Access Compliance Report Public Rights-of-Way (Curb Ramps)

Intersection ID: 10029830 Main Street: KREFELD DR **Cross Street: N/A** Location: **ADA ID: 4F17ECAD7FC8** Ramp Type: PerpDiag Initial Pass/Fail: Fail **Overall Compliance: No** Severity Score: 13.75

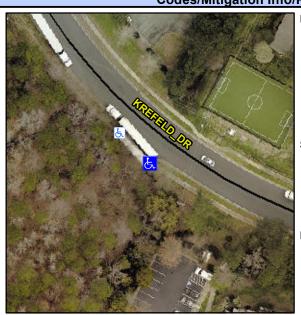
Possible Solutions: Remove & Replace Curb Ramp With **Two New Directional Ramps or** Equivalent. Surveyor Notes: N/A PROW/ADA: Not Found, R304.2.2

Field Measurements/Component Compliance							
	Compliance Description		Data	Compliance Description		Data	
	N/A	Ramp Length (in)	77.0	No	Ramp	Slope (%)	11.1
	Yes	Ramp Width (in)	48.0	Yes	Ramp	XSlope (%)	3.5
	N/A	Flare Type LT	N/A	N/A	Flare	Type RT	N/A
	N/A	Flare Slope LT (%)	N/A	N/A	Flare	Slope RT (%)	N/A
	N/A	Flare Traversable LT?	N/A	N/A	Flare	Traversable RT?	N/A
	N/A	Landing Length (in)	N/A	N/A	DWS	Provided?	N/A
	N/A	Landing Width (in)	N/A	N/A	DWS	Contrast?	N/A
	N/A	Landing Slope (%)	N/A	N/A	DWS	Length (in)	N/A
	N/A	Landing X Slope (%)	N/A	N/A	DWS	Full Width?	N/A
	N/A	Landing Curb? (Y/N)	N/A	N/A	DWS	Offset (in)	N/A
	N/A	Shared Landing?	N/A				
	N/A	Gutter Ponding?	N/A	N/A	Gutte	r Slope (%)	N/A
	N/A	Gutter Lip Ht (in)	N/A	N/A	Gutte	r X Slope (%)	N/A
	N/A	Painted X Walk1?	No	N/A	Painte	ed X Walk2?	No
		X Walk 1 Direction	To NE		X Wa	lk 2 Direction	To NW
	N/A	X Walk 1 Width (in)	N/A	N/A	X Wa	lk 2 Width (in)	N/A
